Subject: CRTPA Thomasville Road Project

**Thomasville Road Multi-Use Path Feasibility Study
CRTPA October 19, 2021 meeting at City Hall**

**Capital Regional Transportation Planning Agency Board Members
Citizens Multimodal Advisory Committee Members
and
Technical Advisory Committee Members**

Cycling Heat Maps

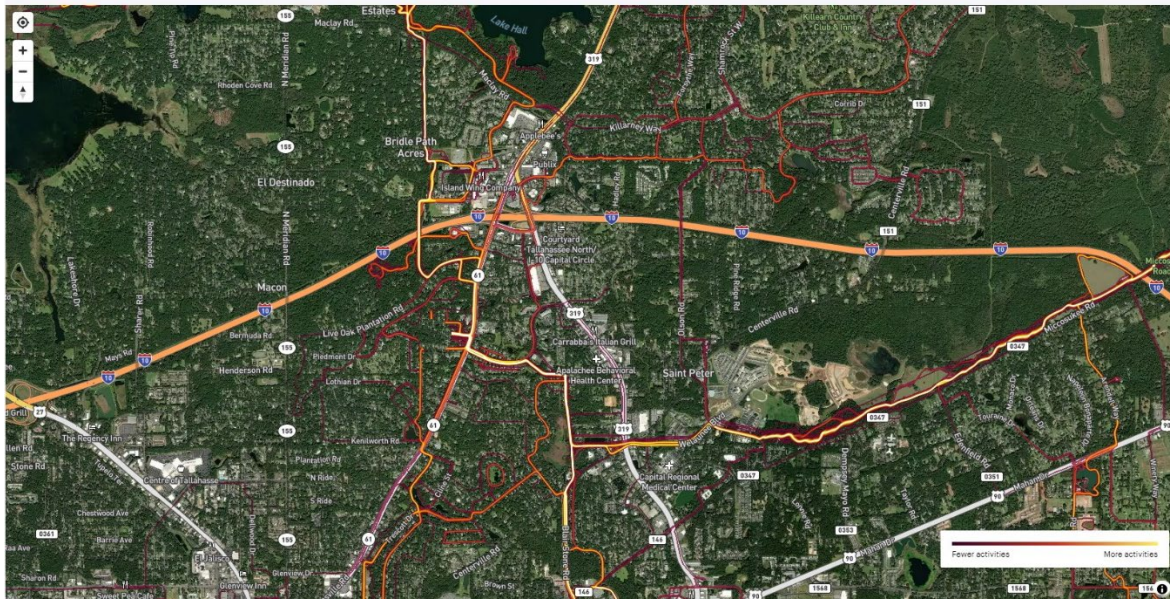
Thank you for the opportunity to provide comments on the Thomasville Road Multi-use Path Feasibility Study. We have been residents in the Leewood Hills neighborhood since 2002 and walk, run and bike regularly along this corridor and throughout Tallahassee. In general, we support this project and think that the feasibility provides some good options that are safe for pedestrians and cyclists. There are some specific aspects of the preferred options we would like considered and incorporated into the project design moving forward. Also, we invite any Committee Member or CRTPA employee to come ride bikes with us along this corridor to experience firsthand pros/cons of some of the options presented. I have included on pages 3-5 "Cyclist Heat Maps" showing the current routes often taken along the corridor for consideration.

The option presented in Figure 16 is preferred as it avoids having to cross the dangerous Live Oak/ Thomasville Road intersection. It also follows the route cyclists currently take so it is more likely to be used (see heat map below).
